SERVICE BULLETIN SB0010

SUBJECT: Exhaust Shroud Clearance to Engine Frame

MODELS AFFECTED: CC18-180A SERIAL NUMBER 0001
CC18-180 SERIAL NUMBERS 0002 THROUGH 0035

FIGURE 1 – Left Side of Engine-Area in question at the mid-right side of photo, engine frame and exhaust shroud outlet

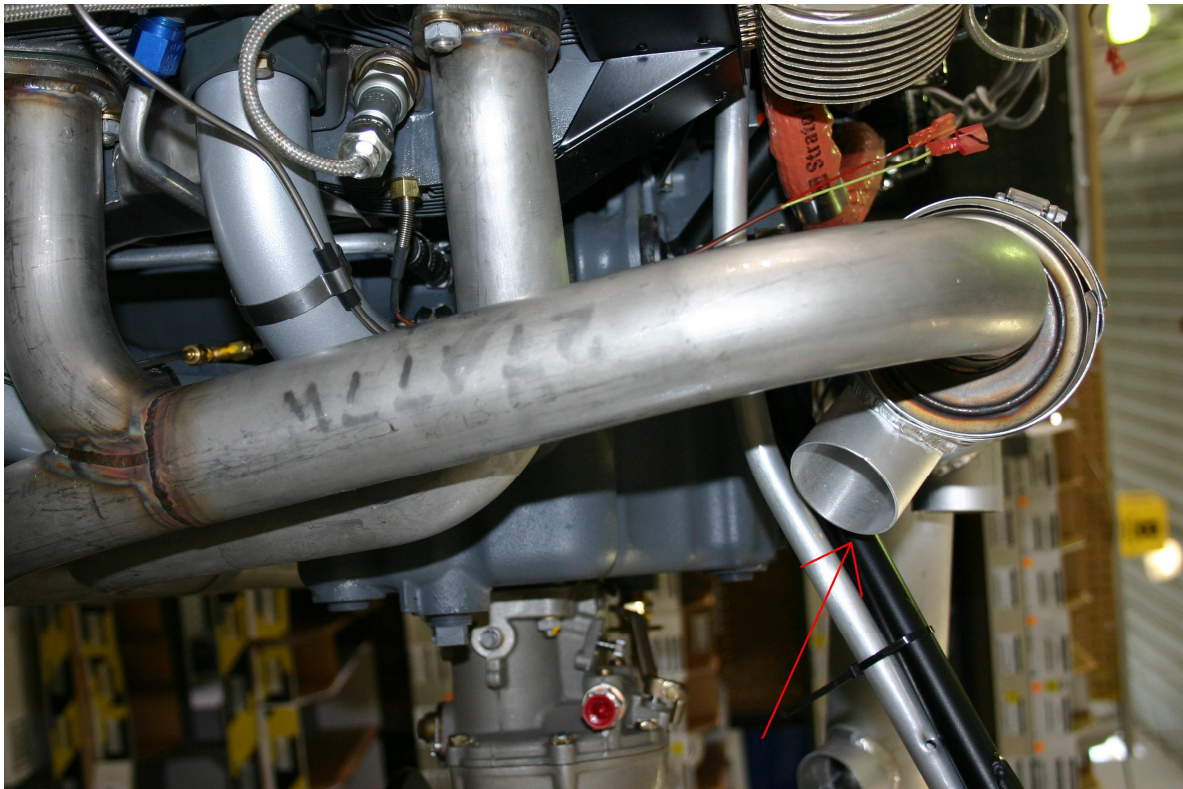
1. Open left side cowling and inspect the area near the cabin heat port on the exhaust shroud and the area of the engine frame for chaffing or damage. Removal of SCAT tubing and hose clamp may be required.
2. If no damage or problems are noted, there is no further action required. As described in the Aircraft Maintenance Manual TC10000AMM Section 05-20, normal inspections should always include inspection for any damage to the exhaust shroud, system, or engine frame.
3. If less than .25" clearance between the exhaust shroud and the engine mount tube is noted, determine if adjustment can be made to increase the clearance. If you are unable to get adequate clearance or the shroud is damaged and in need of replacement, contact Cub Crafters for a replacement that provides for additional clearance in the area. If damage is noted to the engine frame, contact Cub Crafters.

4. When reinstalling the heat shroud (as part of normal annual inspections, this heat shroud is to be removed and inspected as per the Aircraft Maintenance Manual TC10000AMM Section 05-20) care should be taken to locate the exhaust shroud in the proper left-right position and the proper rotational alignment to give as much clearance as possible with the cabin heat outlet and the engine frame. Slide the assembly left-right to center between the exhaust pipes, but also ensure the outlet has .25" or greater clearance to the engine tube.
